Technical Bulletin:

Product: Sanden ECO Heat Pump GAU-A45HPD – G5 Model

Subject: G5 - Correct connection of Power, Tank Thermistor and Wi-Fi cables

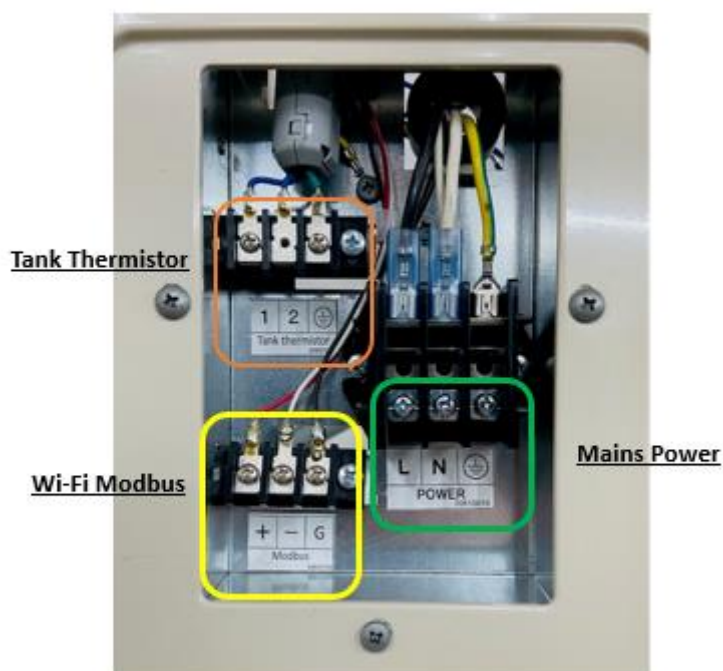
- A new feature of the G5 Heat pump is the ability to connect an external Sanden Wi-Fi Controller.
- This additional interface is labelled **Modbus** and it is found, BOTTOM Left in the connection enclosure.
- Therefore, there are a total of **3** connection points in the G5 Electrical enclosure.

- Prior to installation of any cables, consult Page 13 of the **G5 Installation Manual** and visually identify each connection point in the connection enclosure.
-
- Once all required connections are complete, and prior to powering the heat pump, recheck that the tank thermistor cable is connected to the TOP Left connector as usual.
-
- **Please Note:** Incorrectly connecting the Tank Thermistor cable to the Modbus or Power connectors will result in a damaged Tank thermistor with an Error **H7**.
